**SUPPLEMENT
TO THE
DRAFT FISH AND WILDLIFE COORDINATION ACT REPORT
FOR THE
MODIFIED WATER DELIVERIES TO
EVERGLADES NATIONAL PARK, FLORIDA
THE 8.5 SQUARE MILE AREA
GENERAL REEVALUATION REPORT AND
SUPPLEMENTAL ENVIRONMENTAL IMPACT STATEMENT
FOR ALTERNATIVE 6C**

**U.S. Fish and Wildlife Service
South Florida Field Office
Vero Beach, Florida**

**National Park Service
Everglades National Park
Homestead, Florida**

RE: Supplement to the Draft Fish and Wildlife
Coordination Act Report for the 8.5 Square
Mile Area

Figure S.5.1 Hydroperiods and Average Depths for Existing Conditions with C-111 Project Implementation

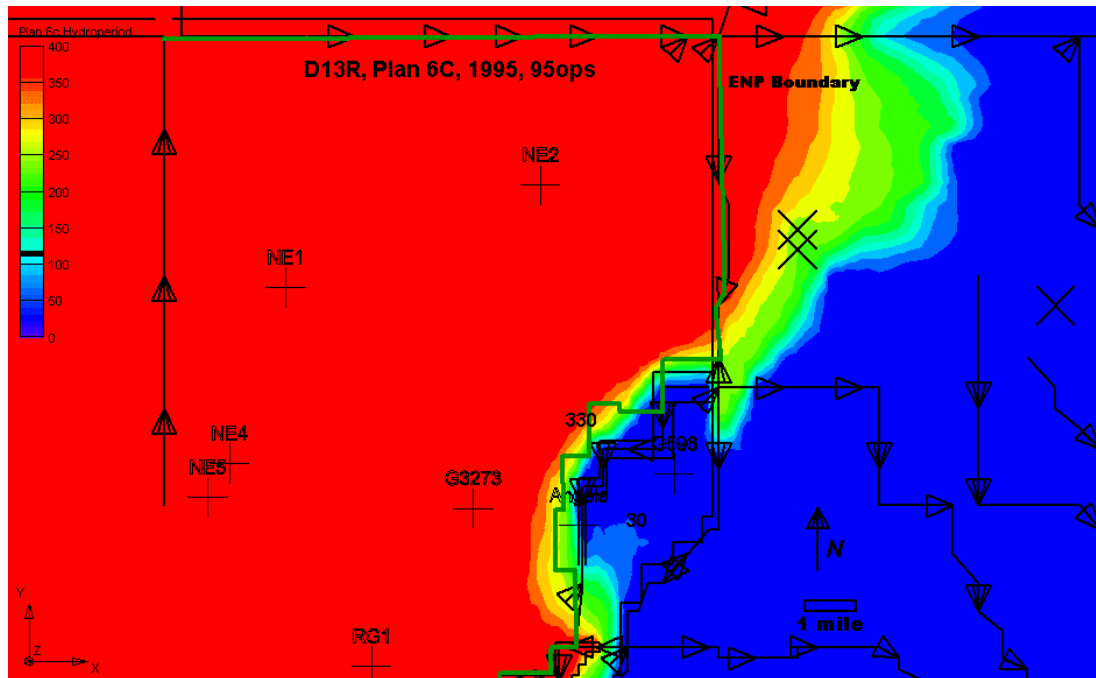
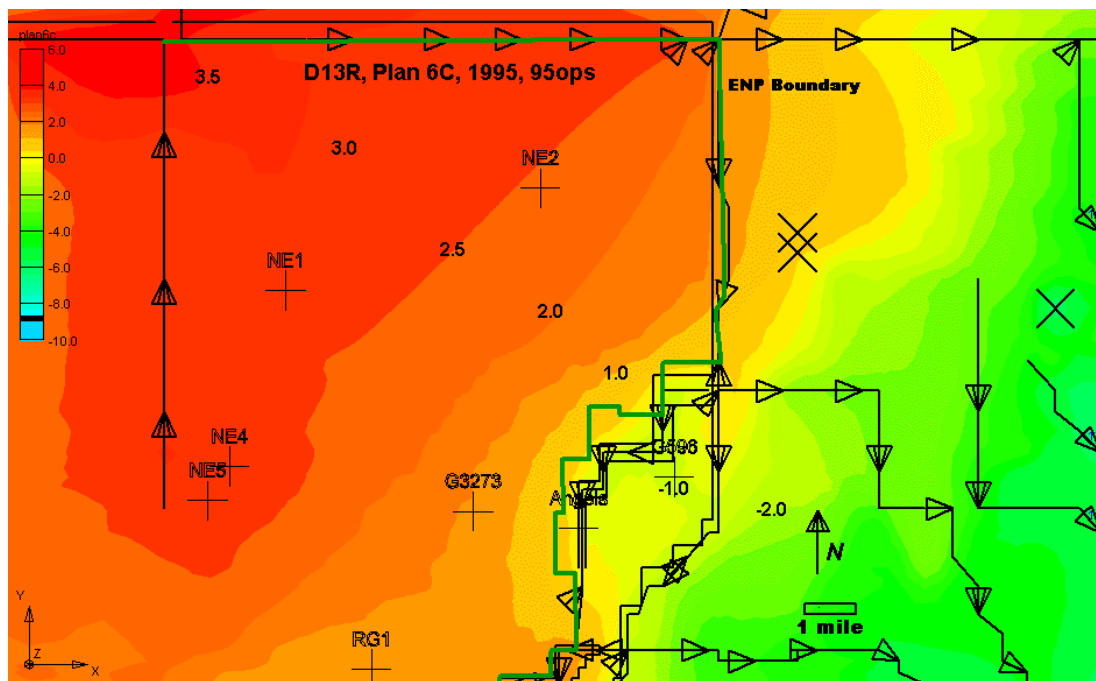
To re-establish historical hydropatterns in NESRS, it is necessary to increase hydroperiod and water depth to restore the peat-forming environment that was historically maintained. Comparing Figure 13 of the Draft CAR and Figure S.5.1, the difference in hydroperiods for MWD Project restoration and plan 6C reveals how placement of a canal and levee around the 8.5 SMA would have a detrimental effect on hydroperiods in NESRS.

Hydroperiods in NESRS would be reduced in almost 2,000 acres of ENP under plan 6C (see Table S.5.1). By placing the canal and levee alignment in the middle of the marl prairie, 75% of the marl forming wetlands are drained. In fact, Plan 6C is designed with the exterior levee extending into ENP which violates the 1989 Everglades Expansion and Protection Act. Another critical measure of NESRS wetland restoration is water depth (Table S.5.). Changes in water depth during the wet year for the various alternatives range from 0.1 feet to more than 1 foot over areas ranging from a few hundred acres to thousands of acres. Under Plan 6C, water depth is reduced in over 27,000 acres in NESRS wetlands.

Figure S.8.4 Difference in average water depths between the restored condition following full implementation of MWD and Alternative 6B

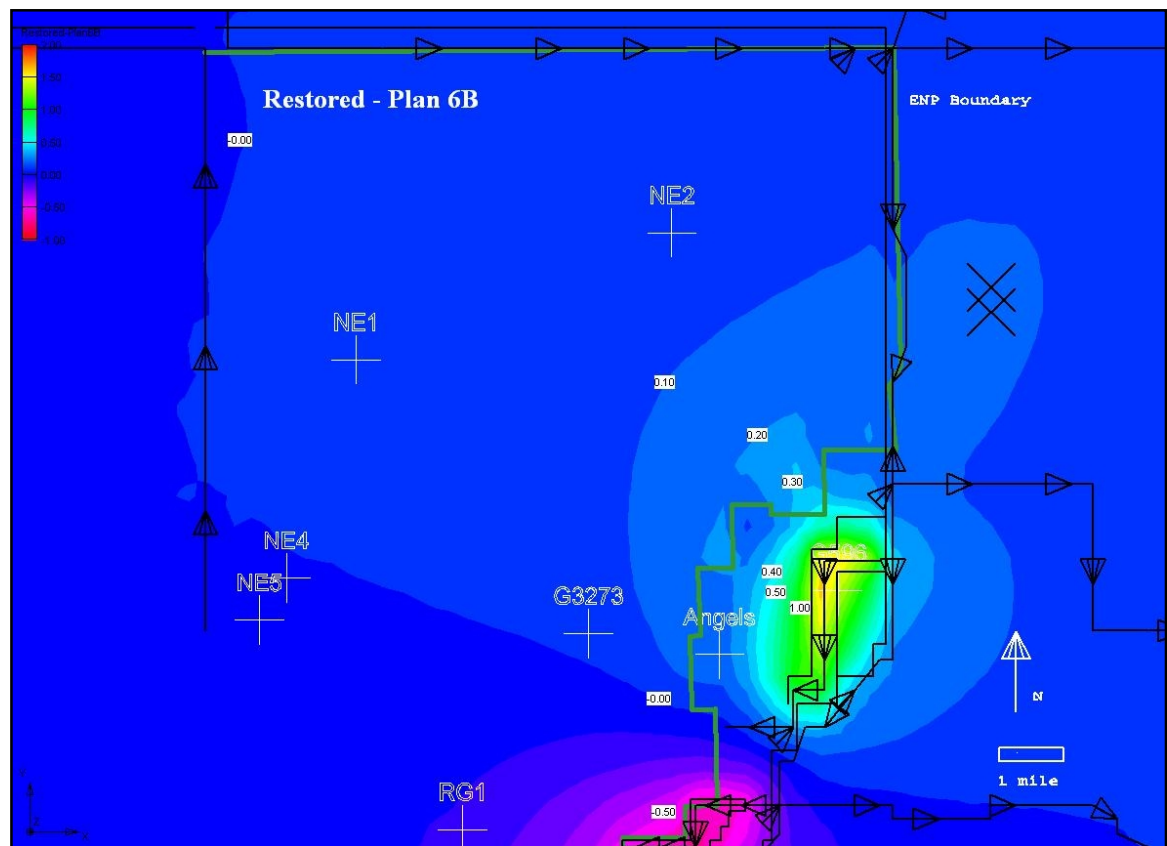
Alternative 6B reduces the spatial extent of lower water levels in NESRS by moving the canal and levee alignment to the east, but it still would reduce water depth over 8,000 acres in NESRS, reducing habitat for the endangered snail kite (Figure S.8.4). Limiting the protected area to the higher elevations in the 8.5 SMA would allow attainment of full flood protection. In providing 1-in-10 year flood protection to the residents, development is expected to increase and the any future projects related to restoration would have to maintain that level of flood protection. This may require increases in pumping to accommodate the relocation of S-356. This increased pumping would cause additional reductions in water depths in NESRS and additional losses of snail kite habitat. Once this 1-in-10 year flood protection is provided, there would be no potential for restoring water levels to the historic peripheral wetlands in the 8.5 SMA (Figure 9 of the Draft CAR). Performance was moderate for snail kites. The WRAP score for Alternative 6B suggests implementation of this alternative would result in a net gain of 1,606 functional units.

Figure S.8.5 Difference in average water depths between the restored condition following full implementation of MWD and Alternative 6C (lowered water depths in NESRS by 0.2 – 1.8 feet relative to restored conditions in ENP following full implementation of MWD)

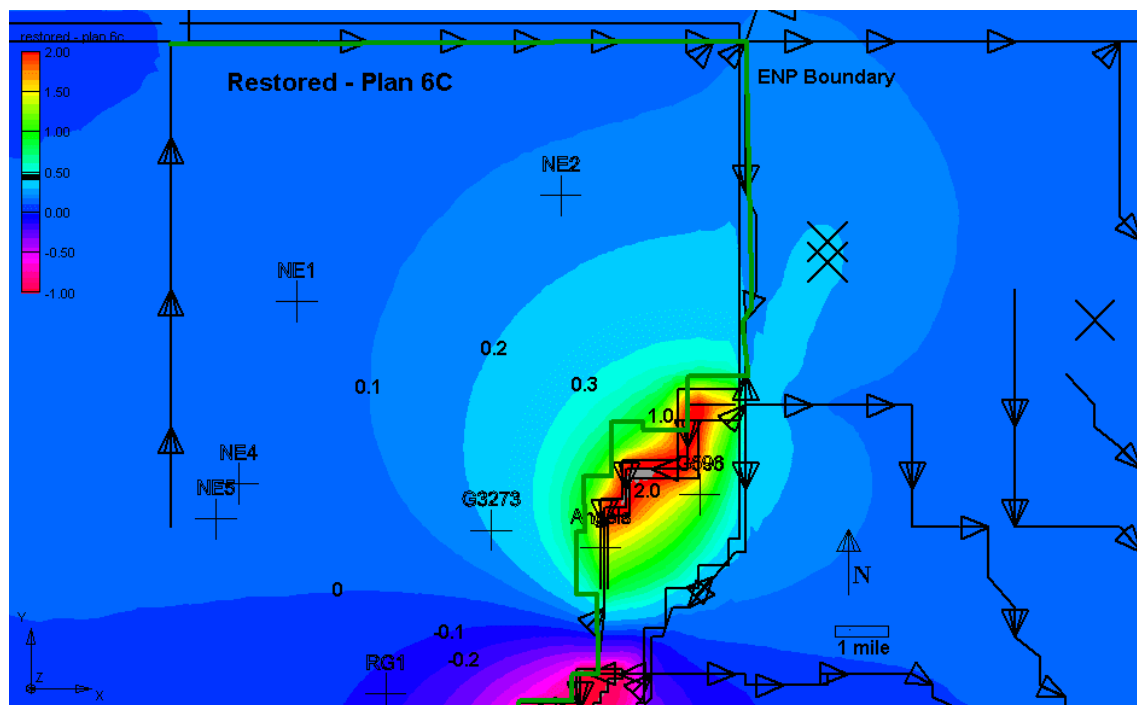
Alternative 6C performed poorly in mandatory hydrological performance measures related to restoration of NESRS, decreasing water depths in more than 27,000 acres in NESRS (Figure S.8.5). The plan provided full flood mitigation but fails to provide flood protection for 3,452 acres, 66% of the designated flood protection zone. Alternative 6C drastically decreases the extent of marl-forming wetlands due to the placement of the canal and levee in the middle of the existing marl forming wetlands. This causes the loss of 75% of the existing marl forming wetlands in the study area (556 acres). Alternative 6C is more compatible with future restoration than Alternative 1 because it moves water south into the C-111 project, but it is still less compatible than other alternatives. This alternative would provide the perception of flood protection, however, adequate flood protection would not be provided and therefore is not viewed as a sustainable solution. The alternative performed poorly for wood storks and snail kites. The WRAP score reflected a loss of 1,215 functional units from existing conditions.

Figure S.9.1 Changes in Water Depths and Hydroperiods When all Alternatives Were Compared to the No Action Alternative (Alternative 1)

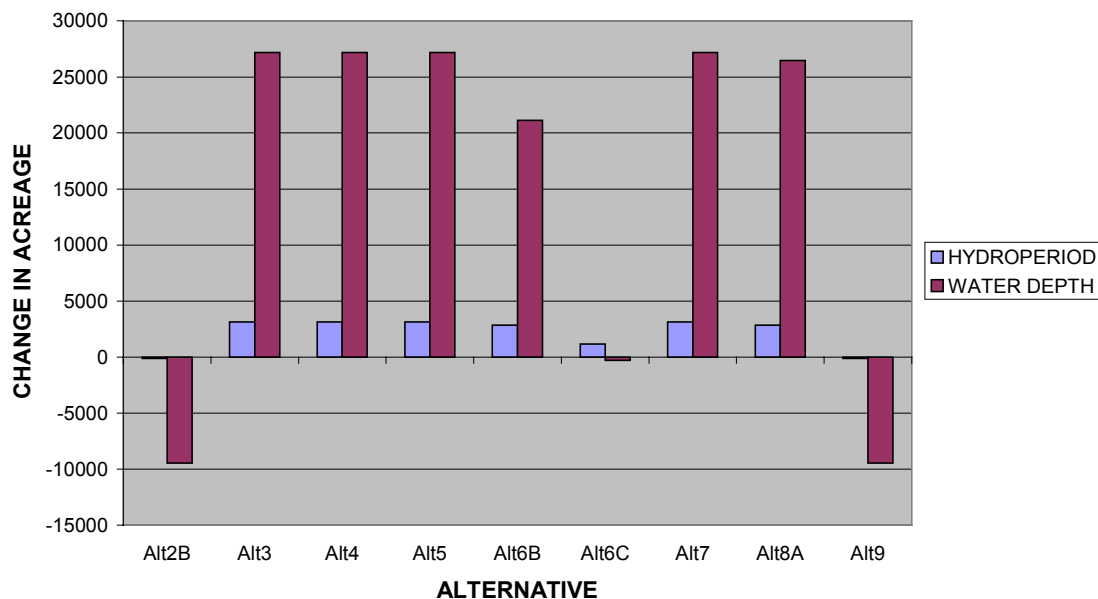
As seen in this figure, Alternatives 2B and 9 performed worse than Alternative 1 for changes in hydroperiod. Alternative 6C performed similar to Alternative 1 for the hydropattern performance measures. Only minor changes were noted for the water depth comparison for these two alternatives. For this reason, it is the opinion of DOI that Alternatives 2B and 9 provide no supplemental benefits for the ecosystem in general or ENP in particular.
